Greater Geelong Planning Scheme Amendment C436 & Planning Permit Application PP-573-2021

Planning Panel - Greater Geelong C436ggee

Statement of Urban Design Evidence
Prepared by Craig Czarny of Hansen Partnership

February 2024

Site Planning Diagram

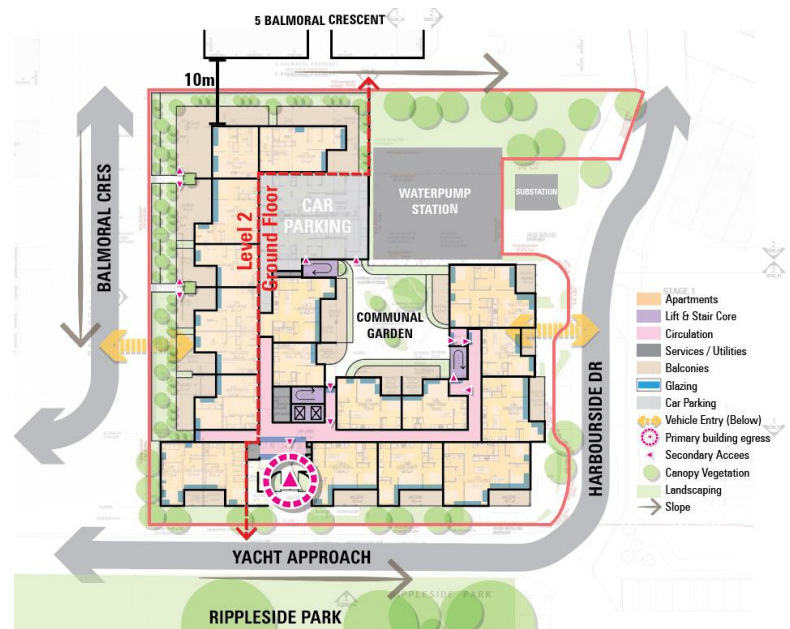
23. The proposed Rippleside Stage 5 development comprising a 6-7 storey apartment building in an ‘U’ shaped configuration addressing Balmoral Crescent, Liverpool Street and Harbourside Drive is in my opinion a fitting response to the Planning Scheme’s strategic provisions that can be reasonably absorbed within the Rippleside neighbourhood. While I accept that Scheme’s neighbourhood character provisions (Clause 15.01-5L) focus on ‘respect’, there are in my view overarching strategic ambitions enabling alternatives responses on a large distinctive site of this kind in the CDZ. Importantly, the architectural concept by SJB is of particularly high quality, well-organised and effectively ‘integrated’ into the site, both in terms of its benching into topography and its relationships (setback, scale and activation) with 3 adjoining streets. The site design is configured around a north facing courtyard adjoining the northern pump station, supporting good separation from the 3-4 storey townhouses at 5 Balmoral Crescent enabling views (from

north and west) to Corio Bay. The proposal is well designed as an architectural form, highly legible (noting address and entries) and broken down into component parts to each of its 3 public interfaces. I interpret this design as medium rise 'garden apartment' model comprising setback 3-4 storey street form with an inset (recessive) top. It is not a typology borrowed from the CBD, but one that sits comfortably in a domestic context while also activating, facing and framing Rippleside Park to the south.

Diagram of the Balmoral Streetscape

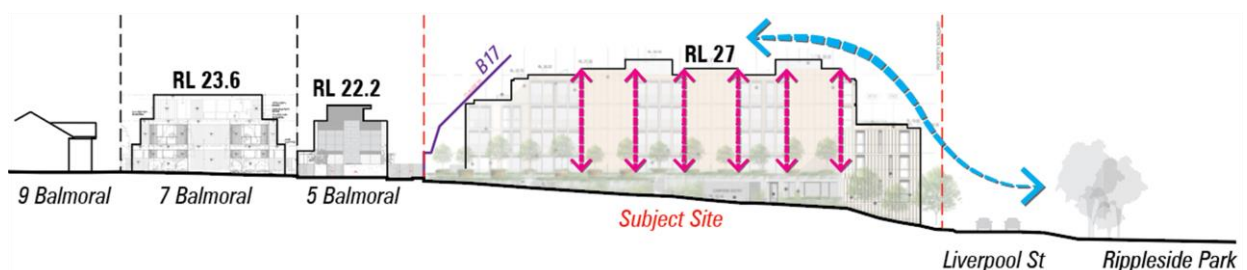
24. A key design issue of interest is the building's height relative to that of approved at (and now constructed) Rippleside development to the east and neighbourhood stock in the GRZ to north and west. The proposal's profile is also exposed to Rippleside Park to the south and Corio Bay to the south-east. When measured numerically, development of 6-7 storeys rises generally to 26m AHD and close to double that identified in the CDP at 13.5m AHD. It is important to note however that the parcel (unlike the plateau leading to the waterfront) is benched into topography by some 9.5m, meaning that the form's projection above street level varies considerably. Recently constructed and approved townhouses to the north at 5 and 7 Balmoral Crescent (in GRZ) rise to 22.2m and 23.6m AHD respectively with the proposal (in CDZ) rising from a setback 3-4 storeys (only 2.4m higher than the neighbours) to 5 storeys downslope to the southern corner with Liverpool Street and the Park. The presentation of a 4-6 storey profile to the Park is familiar in metropolitan Melbourne and Geelong CBD contexts. Importantly, the proposed profile is not uniform, but substantially setback, stepped and articulated in transition to the east to Harbourside Drive opposite to 2 storey townhouses. While I accept that elevated form will be apparent in the view, its upper reaches are rebated from sensitive interfaces to avoid presentation of visual bulk and mass. I have also undertaken inspections from further south and east (including the Geelong CBD waterfront) and consider medium rise form acceptable in the frame of reference of other form, such as larger port and industrial structures to the north.

Artistic Render of the Rippleside Park frontage

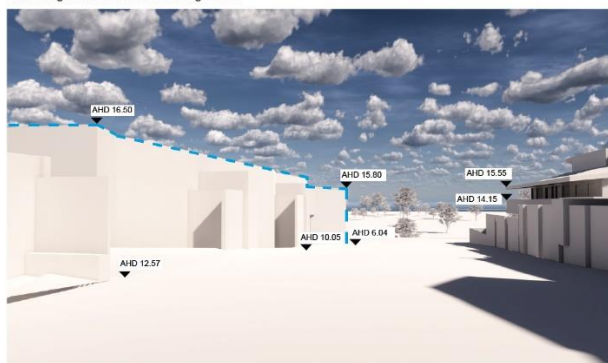
26. Concern has been tabled in relation to the proposed development's profile to Rippleside Park to the south. The proposal will present as a 6-7 storey form, comprising principally a 4-5 storey street form with 2 storeys inset some 8.5m behind the parapet. The profile of the upper form will be visually and spatially recessive, with attention drawn to the articulated southern street form offering advanced surveillance and activation to the Park. Views across Rippleside Park are varied, given its undulating topography and breadth of between 130-200m (north to south). Given the character of the landscape and proliferation of recreational activity to south and east edges, I do not believe the visual impact of upper form (or total building) will be overwhelming. I have inspected the Park condition immediately across Liverpool Street, including the vegetated precinct (comprising Casuarina, Melaleuca and Gums) and consider it less sensitive for Park users (albeit recognising its habitat value). I have also inspected shadow diagrams across the Park at both the equinox and winter solstice. I consider the equinox an appropriate test in such a location (winter is not specified in the CDZ, nor is this a CBD precinct where public open space is particularly scarce). At the equinox (due to upper-level setbacks), shadowing is broadly equivalent to that cast by the approved Building H form. The shadowed area in question sits within filtered shade from vegetation (and incorporates a picnic shelter which itself is covered). I do not consider such shadow to threaten the viability of the existing vegetation or its value within the park edge. I believe the benefits of surveillance and activation of the Park edge (resulting from the proposal) outweigh any real or perceived visual impost when viewed from within Rippleside Park.

View from Balmoral Crescent looking south (blue dashed line indicating previously approved 'Building H')

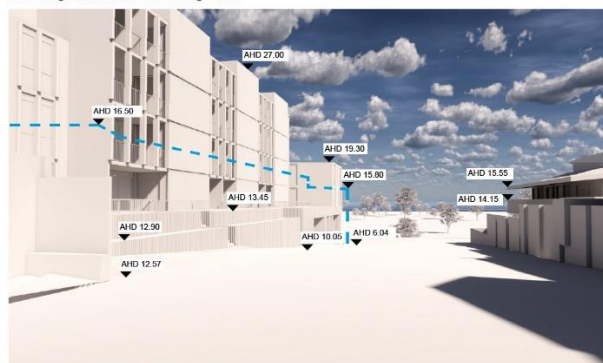
28. This of course does not suggest a complete building out of the site and blocking all views. Having inspected the Development Plan, I believe the neighbours at 5 Balmoral Crescent will maintain views to the east and south-east given the gap between their south windows (and courts) and the proposal's northern face. The property at 52 Walker Street (north-west) has upper-level glazing and decking with wide aspect across the site. These views will be hampered; however an eastern aspect will be maintained between 5 Balmoral Crescent and the proposal's northern 3 storey wing. Views from this elevated location to the south-east (across Rippleside Park to Corio Bay) will however be concealed by elevated form (above 3 storeys). To this end, there would be merit in drawing back the south-west street wall corner (only) above Level 3 (above 15.8m AHD) to enable a wider panorama towards Corio Bay and the Geelong CBD. This could be achieved by eroding, opening or setting back the south podium wing extension at the corner (Apartment 3.01). This also benefits those walking within Balmoral Crescent leading downslope to the south. Views from the deck of the 1-2-storey property at 41 Liverpool Street will also be aided by such modifications. With this adjustment, I am satisfied that viewsharing is effectively achieved in the design, however it would also be appropriate to temper the Incorporated Document (UDG) expectation for 'unlimited aspect' (at UDG: G2). These adjustments demonstrate a neighbourly response that is sensitive to its immediate context.

- c. Erosion of the south west corner of the proposed development (Apartment 3.01) to open views.
 - d. Confirmation of design delivery through novation of the architectural and landscape design
